**GE MONOGRAM REFRIGERATORS
BOTTOM-MOUNT & SXS MODELS
1993 to CURRENT
INTERMITTENT LIGHT &
EVAPORATOR FAN SWITCH OPERATION**

REF 09-00

JUNE 2000

Fig. 1

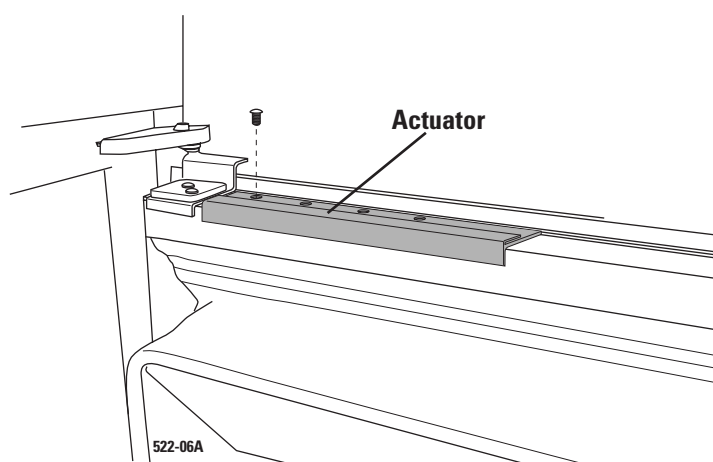
Complaints listed below are likely to be the result of intermittent contact of the refrigerator doors with the light and evaporator switches in bottom-mount and side-by-side models.

1. Too cold or too warm
2. Intermittent operation
3. Light staying on
4. Fan not running
5. No or low ice production

The field correction part, **actuator** **WR02X10470** will correct the problem. You will need an actuator for fresh food and freezer doors.

1. To determine appropriate screw location, place actuator against hinge overlapping back edge of door.
2. Remove actuator and existing screw.
3. Remove release paper from back of actuator. Align actuator with proper screw hole and reinstall screw as shown in Figure 1. Press down on opposite end to ensure adhesion to door
